DRB CASE ACTION LOG (SITE PLAN B.P. & PREL & FINAL)

Project Name: RICHFIELD PARK

**CITY OF ALBUQUERQUE
PLANNING DEPARTMENT
Development Review Board
3/3/04 Comments**

A PROPOSED SITE PLAN
SCALE: 1" = 20'

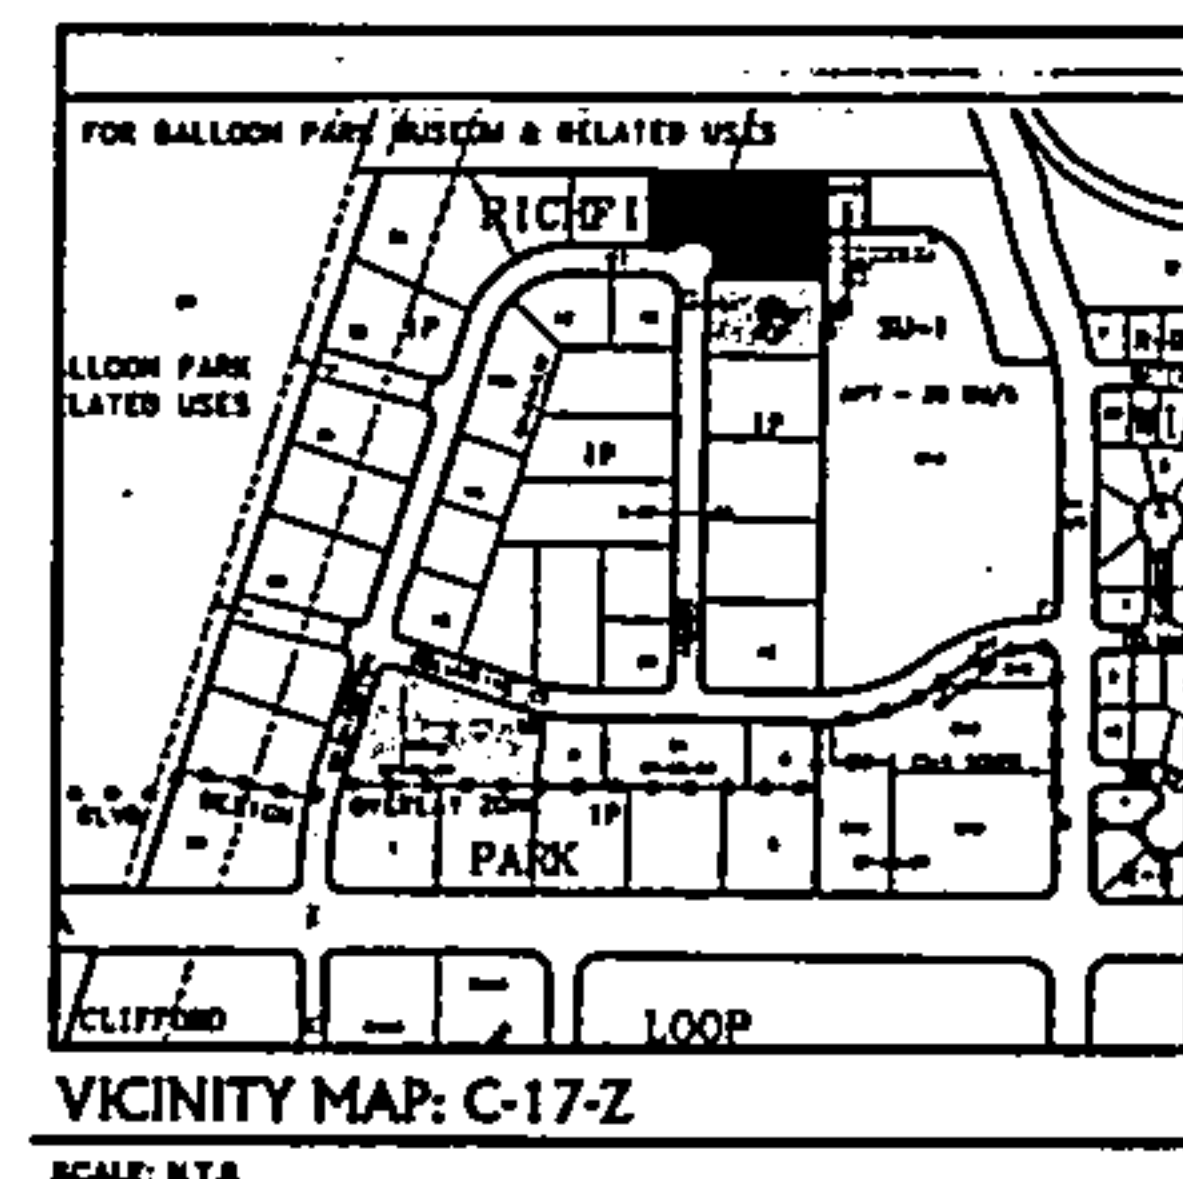
- Keyed Note 5 refers to a CMU wall but points to the edge between 2 parking stalls. Where is the 4' CMU wall planned to be built?
- How high is the CMU wall along the south side of the property? Is it existing?

- Actually all the Landscape Notes should appear on the Landscape Plan.
- All buildings must have a 15 foot rear yard setback. These two buildings appear to have only a 5' rear yard setback from the property line.

5. Lighting: EPC Condition # 13 states that parking lot light fixtures are to be a maximum of 16 feet in height. The site plan lighting is 20' tall.

LANDSCAPE NOTES:

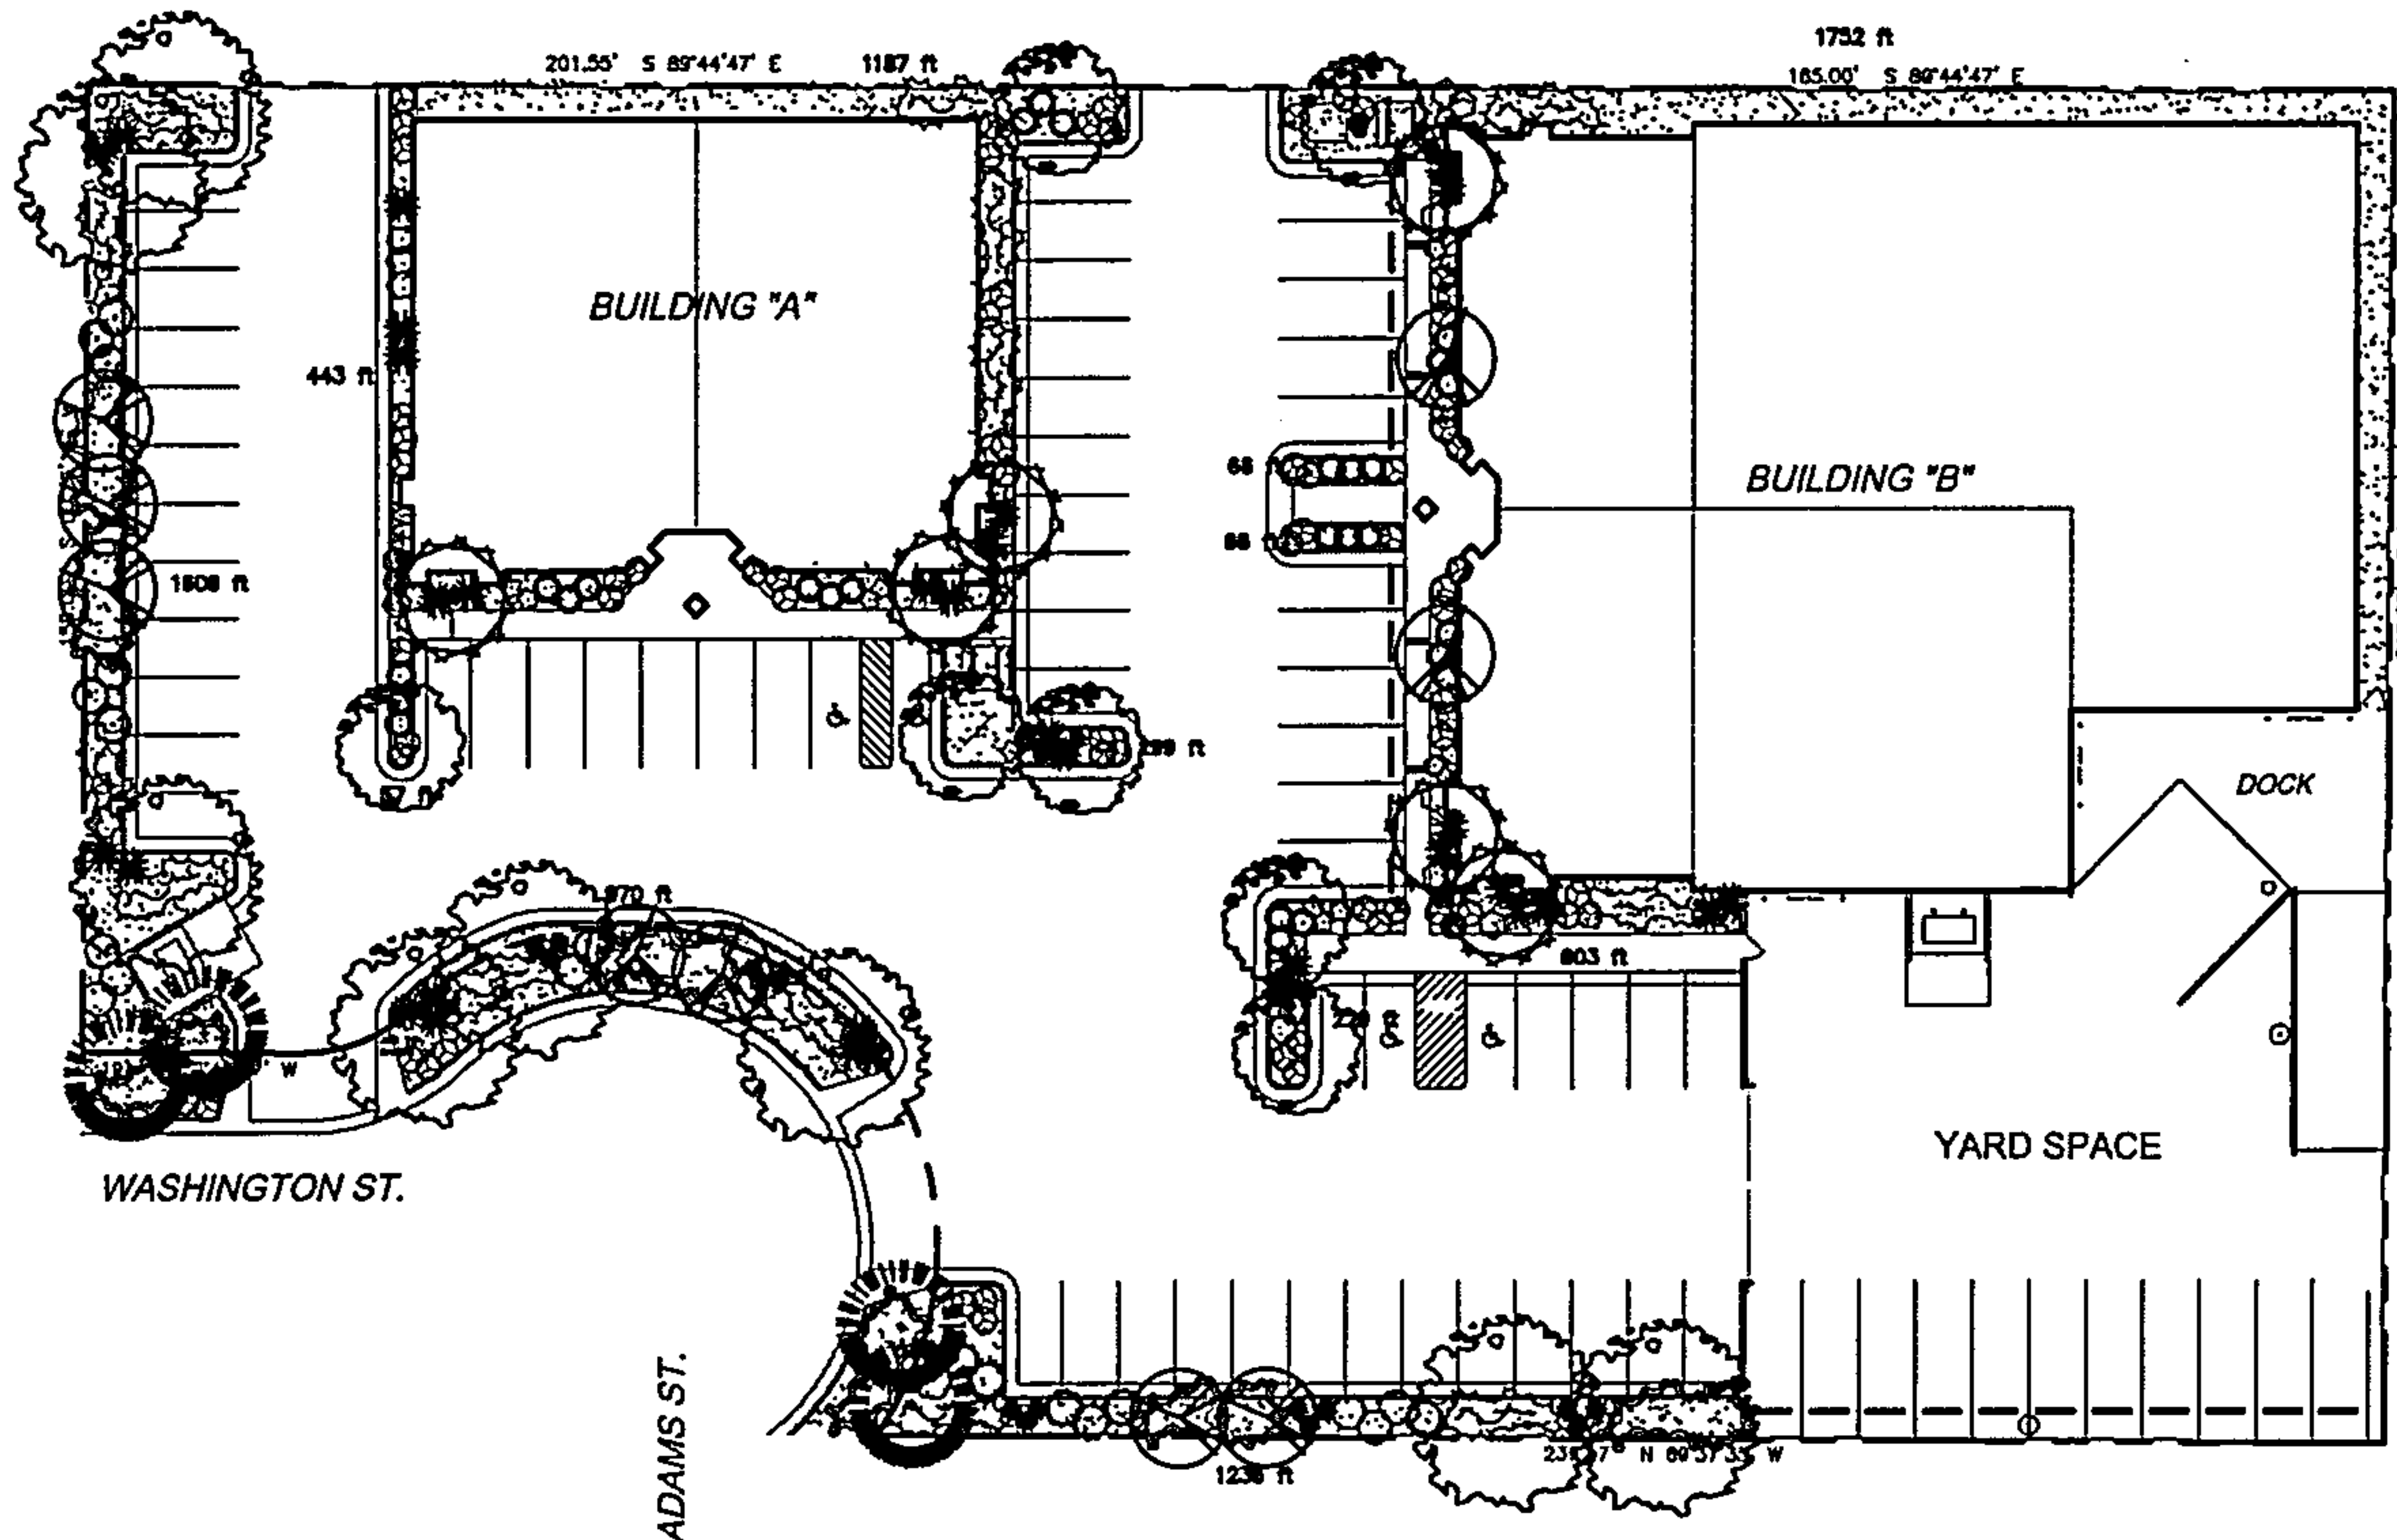
- Landscape Notes: #4 says that responsibility for landscaping & irrigation maintenance, including abutting public right of way, lies with the property owner of Lot 30A. On the Landscape Plan, the note says this responsibility lies with the property owner. Please correct this discrepancy.

- Please substitute other drought tolerant plants for the junipers. Junipers are high allergen plants. Rosemary is one possible substitute.
- Chinese Pistache needs a water use symbol.
- Each landscape bed should have the square footage listed by the bed. There is a footage noted for each bed. However, if this is the square footage, a change in the notes is needed to indicate as such.
